THE CITY OF WALTHAM  
MASSACHUSETTS

**Boiler Replacement, Waltham Library**

**ADDENDUM NO. 3**

Sept 12, 2017

M200

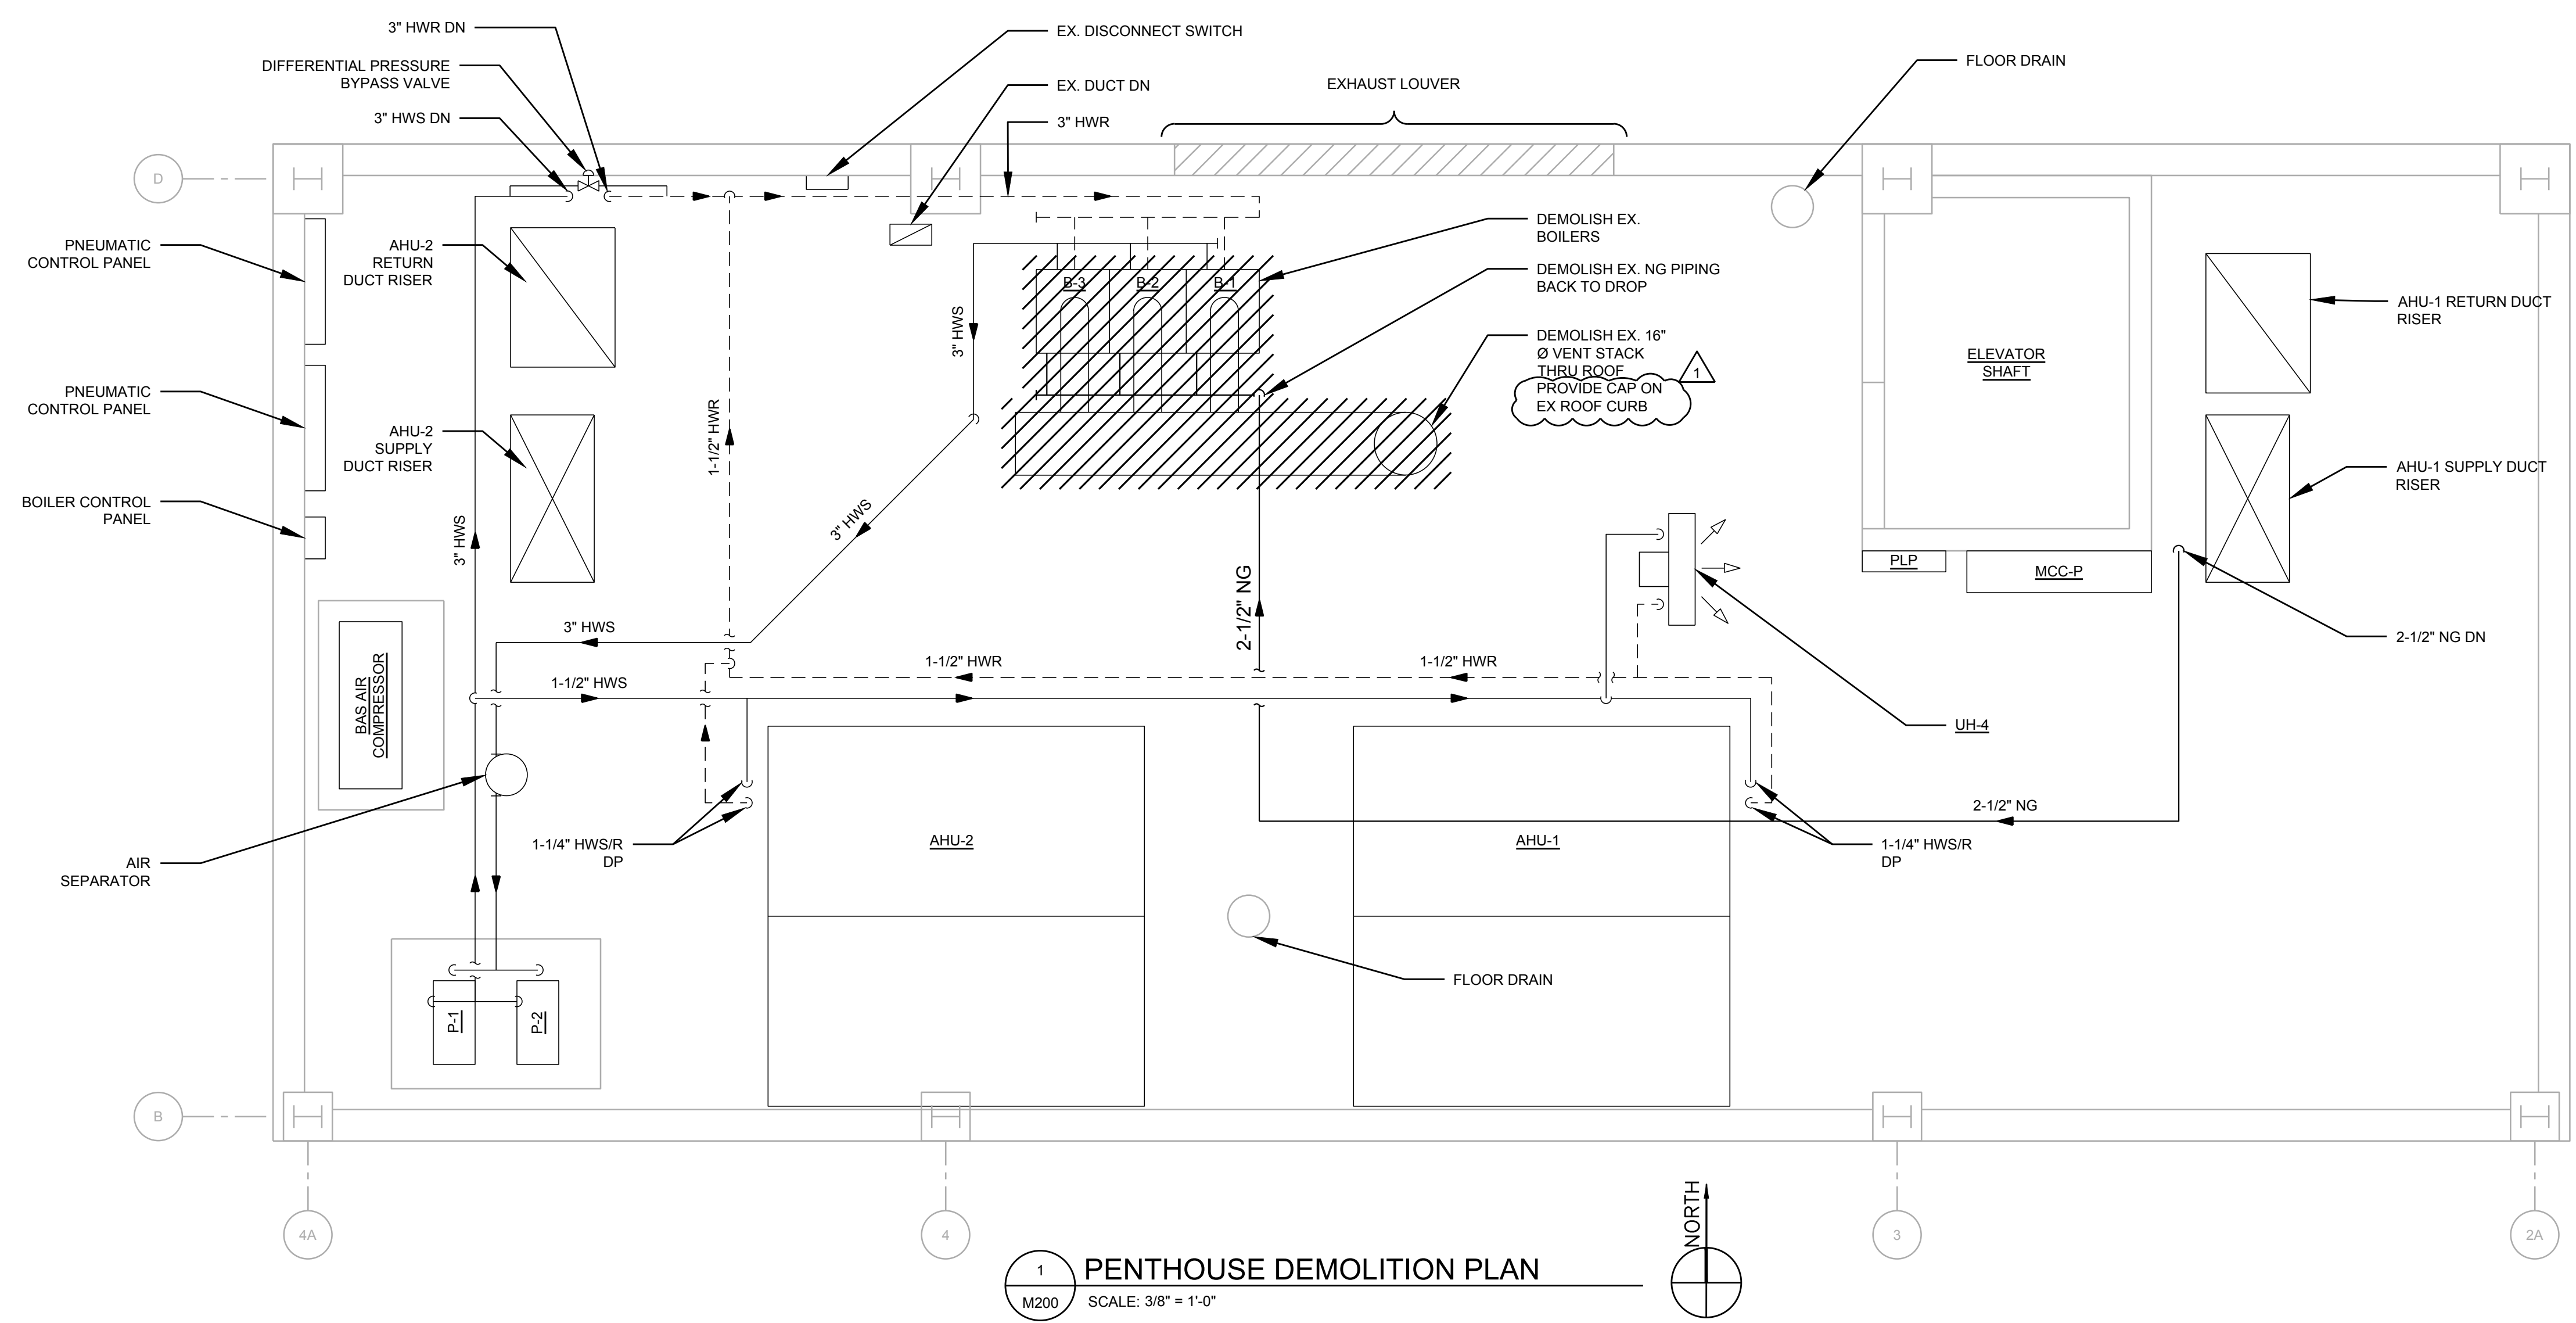
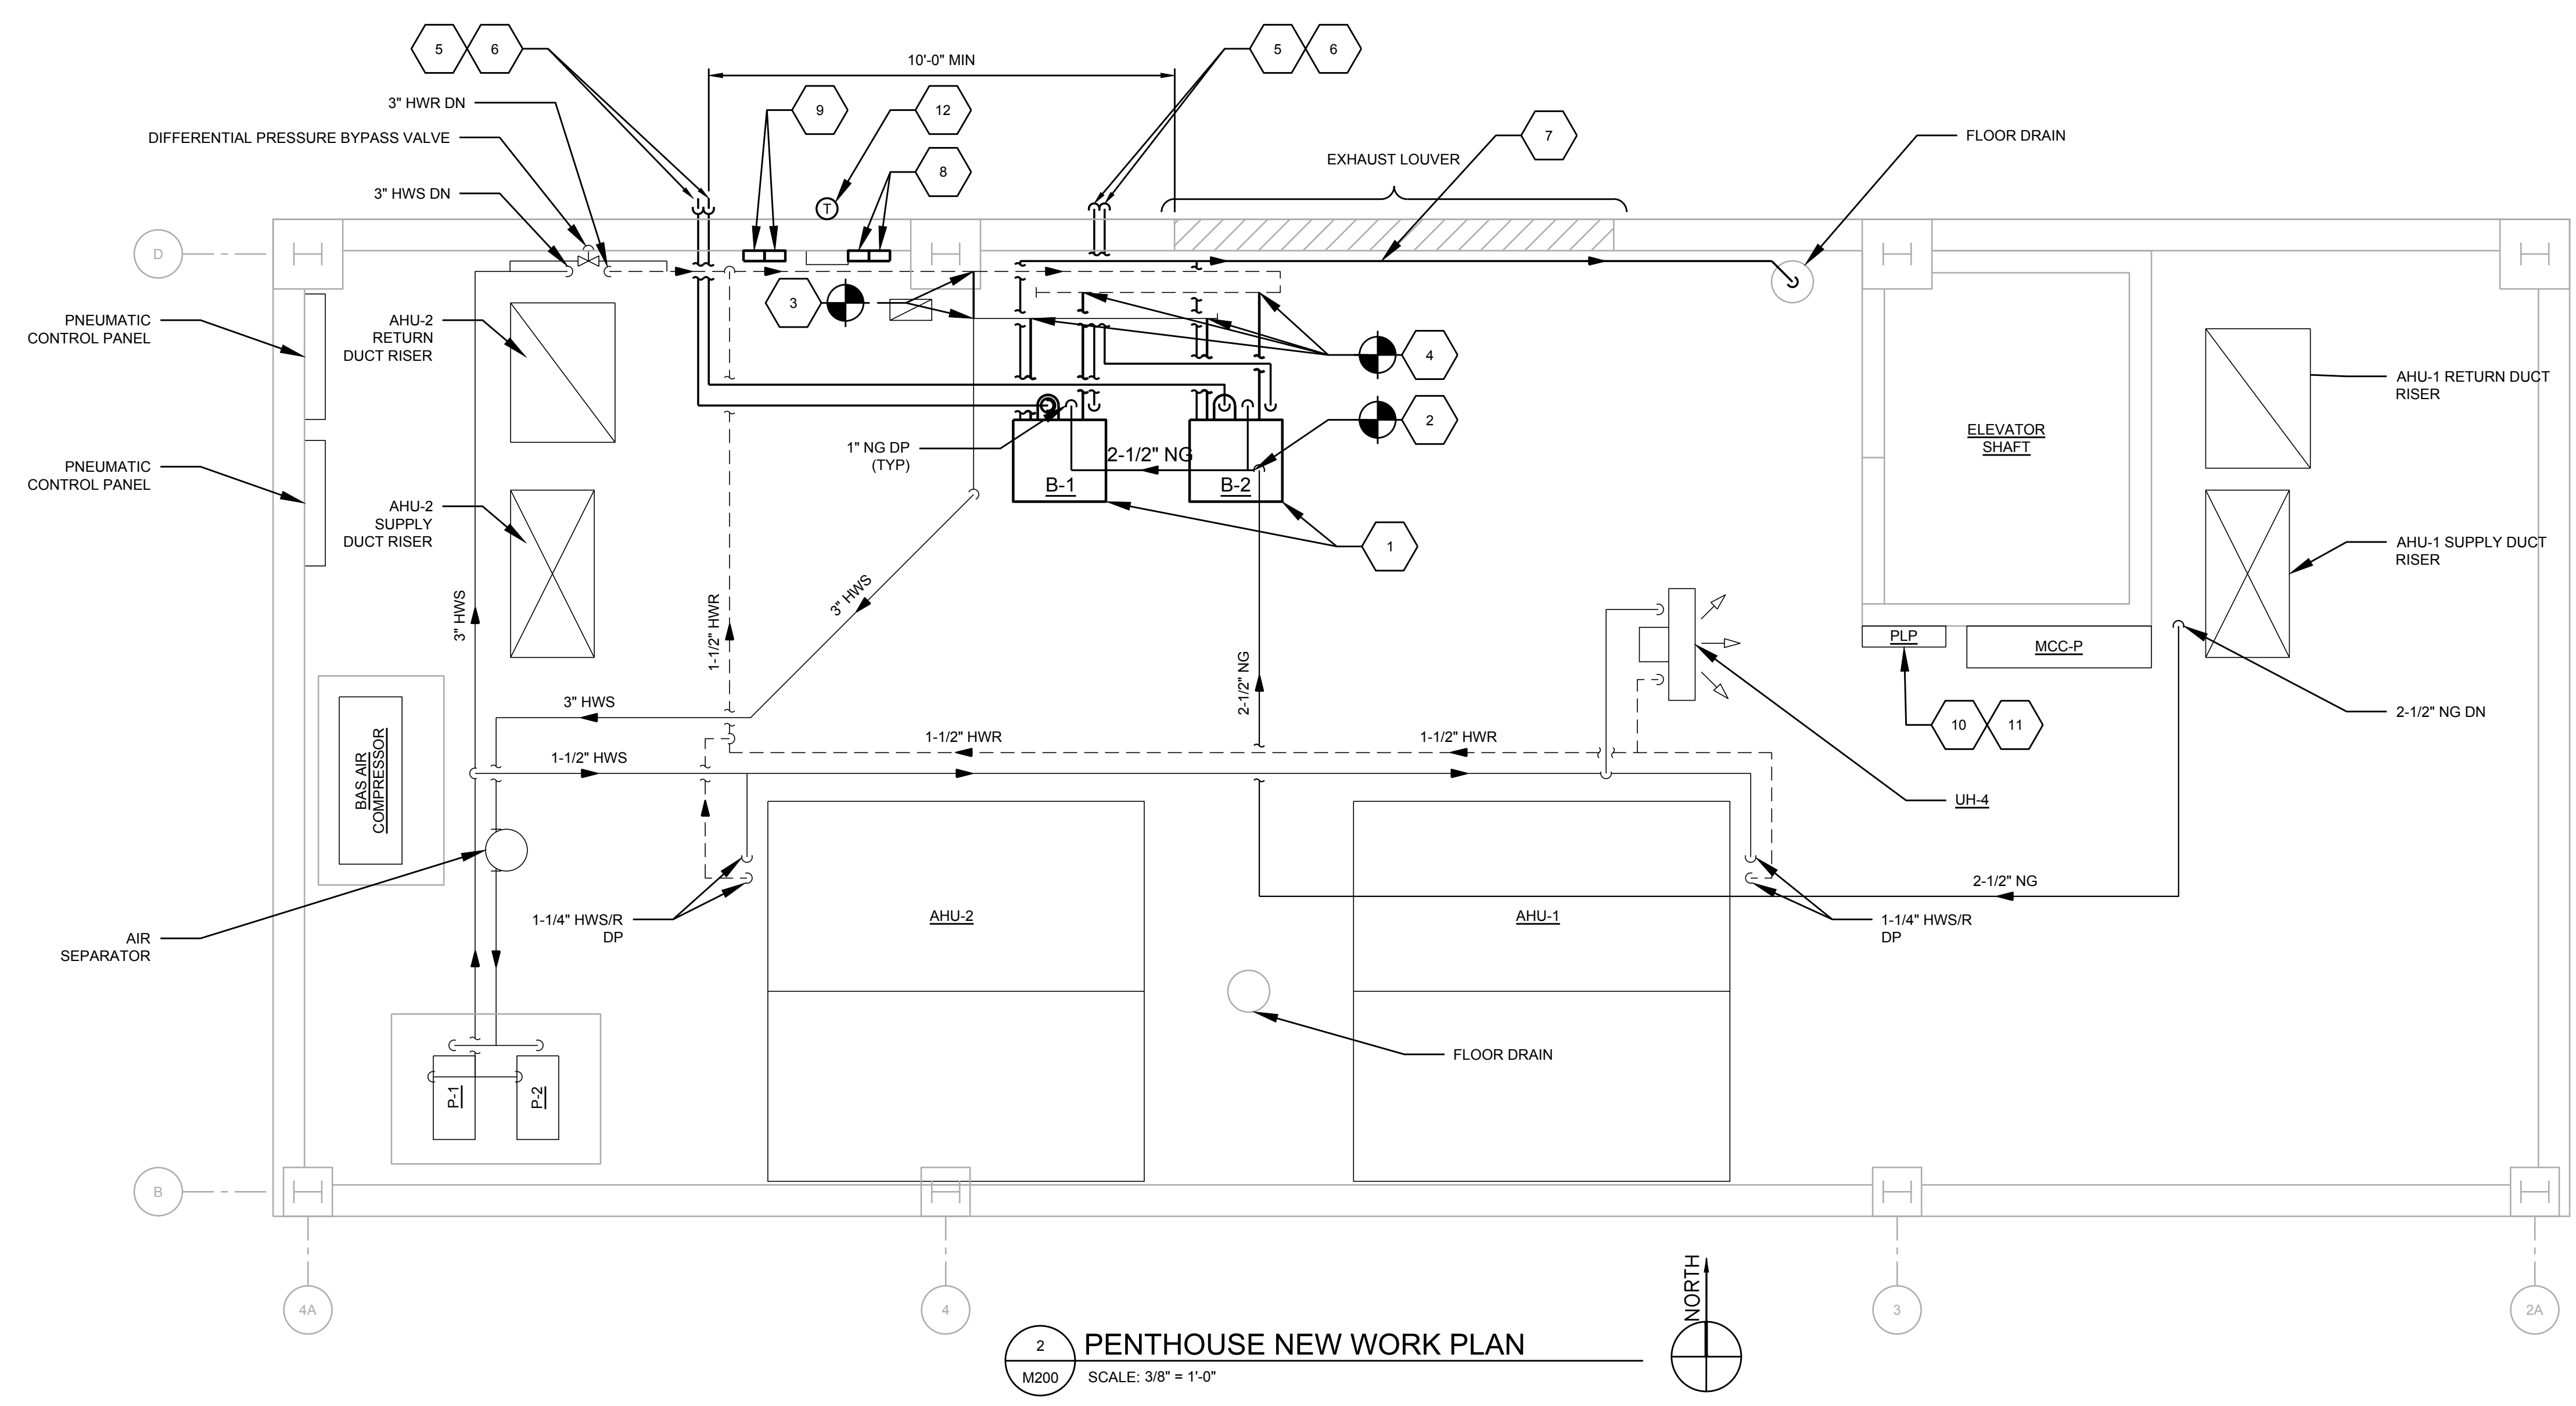
b) **DELETE** Drawing M-200 in the bid document and **REPLACE** WITH THE ONE ATTACHED HERE. Drawing M-200 has also been revised to require the contractor to provide a cap on the existing roof curb after the B-1, 2, 3 flue has been removed.

SEQUENCE OF CONSTRUCTION NOTES

- HEATING SYSTEM DOWNTIME SHALL BE COORDINATED WITH THE OWNER, AND SHALL ONLY BE ALLOWED ON FRIDAY, SATURDAY AND SUNDAYS UNLESS TEMPORARY BOILERS ARE PROVIDED.
